QUARTERLANDS 3

Planning application ref: LA05/2022/0033/F Lands between 58 and 66 Quarterlands Road, Northeast of 54B-C & 56 Quarterlands Road, North of 7-12 Rural Cottages and Southeast of 4-7 Zenda Park, Drumbeg

**SUBMISSION OF REVISED AND ADDITIONAL INFORMATION - PLANNING APPLICATION REF: LA05/2022/0033/F
LANDS BETWEEN 58 AND 66 QUARTERLANDS ROAD, NORTHEAST OF 54B-C & 56 QUARTERLANDS ROAD, NORTH
OF 7-12 RURAL COTTAGES AND SOUTHEAST OF 4-7 ZENDA PARK, DRUMBEG**

Fig1 A PSD

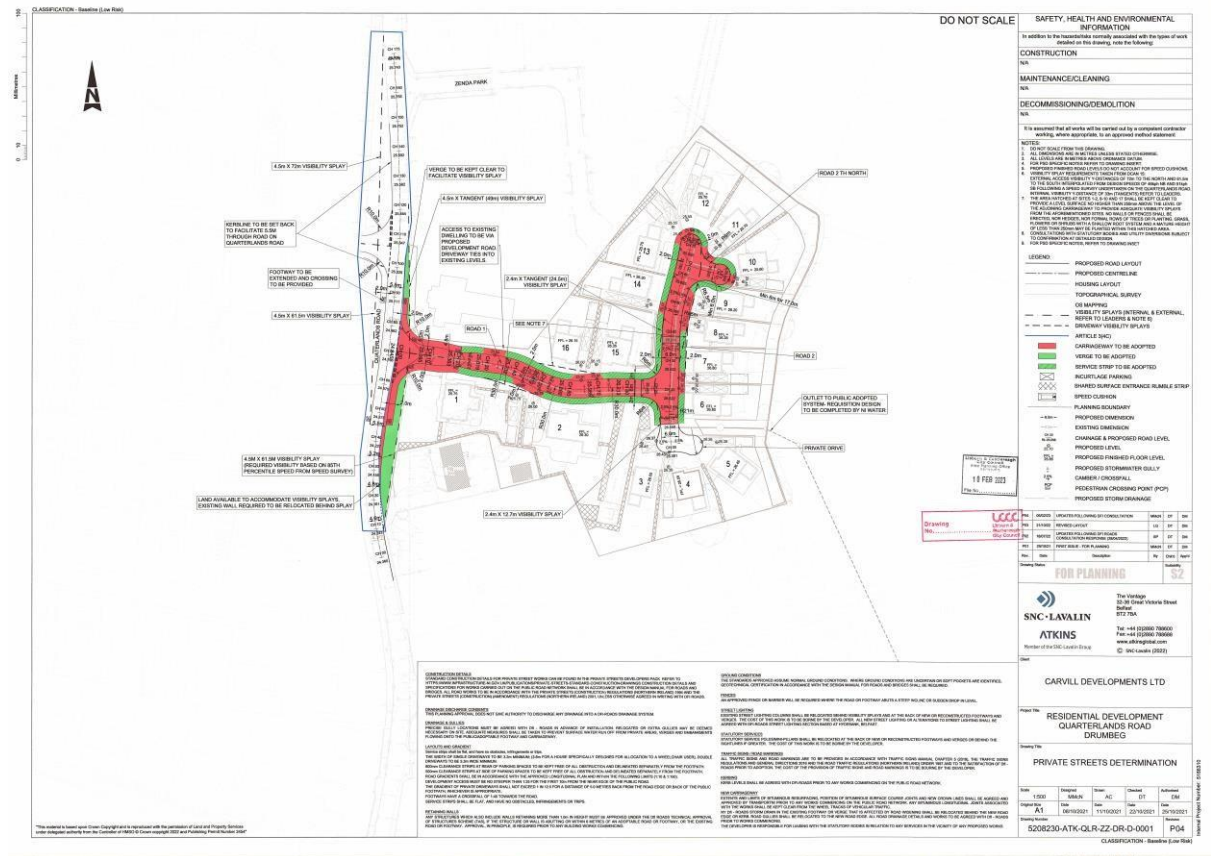
This PSD (Fig1A) as the Developer indicated in their accompanying Letter is an “amended version” of the document they submitted in Oct 2022

If this new PSD is a stand-alone document, then the previous footpath from the October 2022 PSD on either side of the road has been removed beyond the entrance into the site and applies to the totality of the site. All on-street car parking (14 cars) has also been removed but the in-curtilage car parking spaces for 42 cars remain.

Whilst this new PSD seems to emphasise visual splays both at the entrance and within the site (for Roads purposes) the plantation of bushes etc at the perimeter of the site and the Fencing itself no longer exist.

Also, in Note 7 where they comment on no walls within the site, they refer to Number 17 which I assume is now 66 Quarterlands Road as there is no site 17 on these drawings.

Again, No details have been given for Storm Drainage and Wastewater.

Fig 1B Longitudinal Profiles.

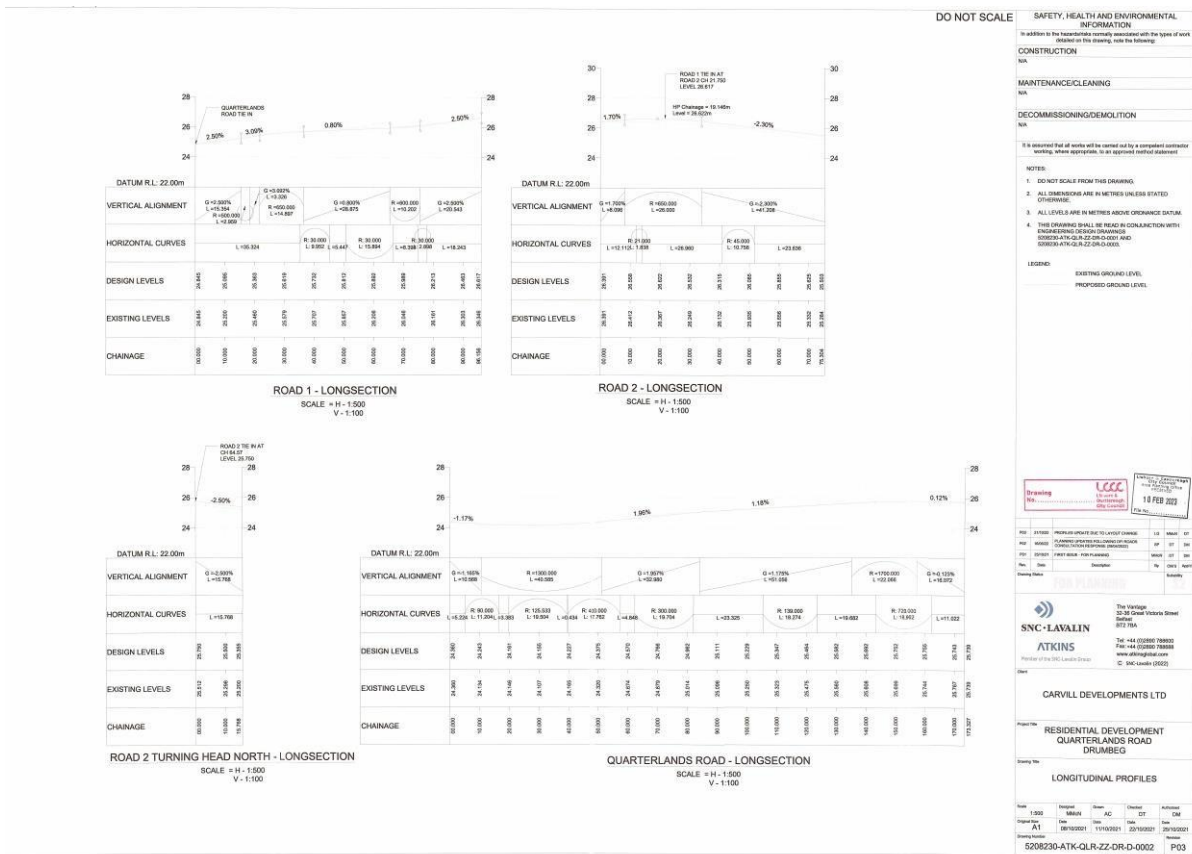
The "A1 Longitudinal profiles" Fig1B unfortunately cannot be read from the data on the document. This is probably because the drawing is designed to be a site drawing printed on A1 size paper, and as such would be readable for the Contractor. However, it is unlikely any revelation in the data as it will simply reflect the various surface levels and depths of the services below and be in accordance with their original proposal.

Fig4 Enlarged Map of the junction of Quarterlands Road and the proposed entrance to the site.

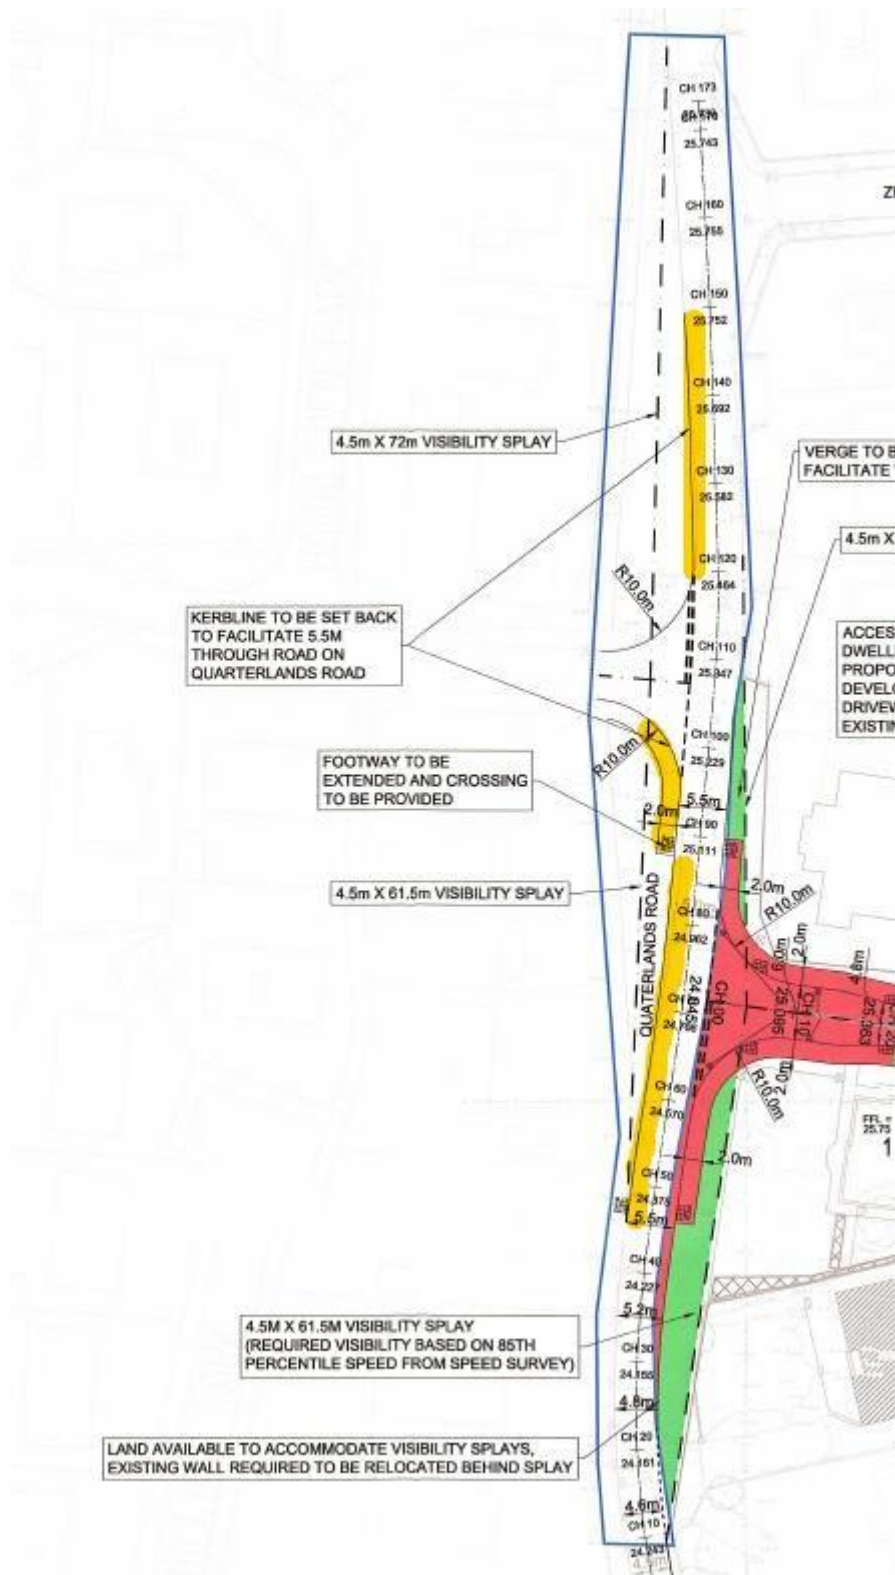
Nevertheless, from the Residents viewpoint it is important to emphasise that the removal of a *sliver* usually involves a Digger on the remaining part of the Green which causes damage to the grass which should require immediate repair otherwise it will also start looking muddy from the Digger Tracks.

In addition, one can see that on the South side at the end of the yellow area the road becomes 4.6 M its original width and also at the North end. So, you increase the width of the Road at the entrance and exit from the site to improve the visual splays but there is no comment regarding the increase in volume of the traffic on the 4.6 M Quarterlands Road coming from the Ballyskeagh and Hillhall Roads necessitated by this 16 House development.

Furthermore, the storage of materials and construction plant is to be on site. That is a minor part of the problem. All the vans, cars etc. bringing the workmen to the site and also lorries including Diggers will be occupying the remainder of the already busy Quarterlands and Hambleton Roads particularly any grass verge or remaining footpath will also be occupied. To Police that is an impossible task for Private Streets Inspectors. There is no alternative for them to Park when they are working on the site.

This parking of vans, cars etc for all of the working hours will cause the width of the Quarterlands road for other Residents cars to narrow further. So, at peak times of working hours a bottle neck will be created extending along the Quarterlands Road. This will add a significant hazard to parents leaving off and picking up children at the Pre-School where Quarterlands entrance joins the Ballyskeagh Road. Also, Quarterlands Road is used frequently by Farmers with large Heavy equipment accessing their fields.

Fig4 is a 'scanned version of the proposed PSD drawing showing the work on Quarterlands Road associated with the development and in particular where the scheme affects the top and bottom greens at the junction of Hambleton Park/ Quarterlands Road shown (highlighted in yellow). This work consists of removing a slither of both greens to widen the road to 5.5m and the extension of the footway on the bottom green to provide a pedestrian link to the footway at the frontage of the development.

I have asked our Section Office, Lisburn and Castlereagh, who deal with permits for the use of DfI Roads footways/verges by the public to ensure that the developer does not use these greens to store plant or materials.

I have also informed our Private Streets Inspectors, who will oversee the work associated with the Private Streets Determination if the development comes to fruition, that all materials /plant associated with the site shall be stored within the curtilage of the development site.'
